URGENT - FIELD SAFETY CORRECTIVE NOTICE

GETINGE CM320

Product Issue: Water leakage CM320, CAPA 326680

Affected Product: 189 units of Getinge Washer Disinfector CM320

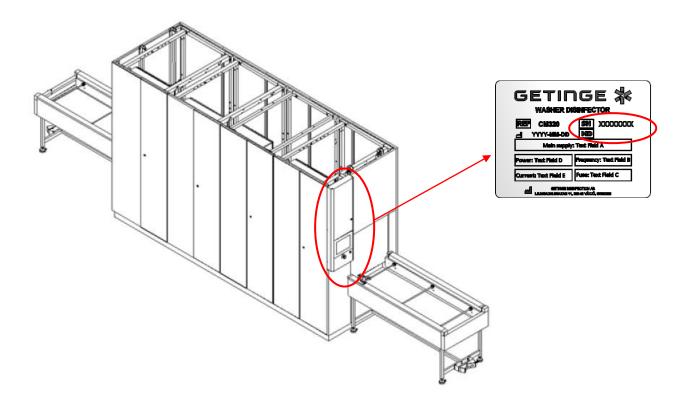
Getinge has discovered a water inlet plastic hose connection that may deform or break due to material fatigue or hose clamp overtightening. A broken hose connection can cause a water leakage and water spray.

This potential for malfunction may be caused by incorrect choice of material when the machine was designed. Other contributors are that the hoses not always are supported and attached to the equipment and that the hose clamps are tightened too hard, which causes deformation and potentially cracks.

The device model is still being manufactured and as we see this issue as a potential long-term hazard and want to prevent any related event from occurring with our customers, Getinge has developed new hose connectors in stainless steel to replace the connectors in plastic.

A correction kit is currently available and the correction will be completed at no cost to affected customers.
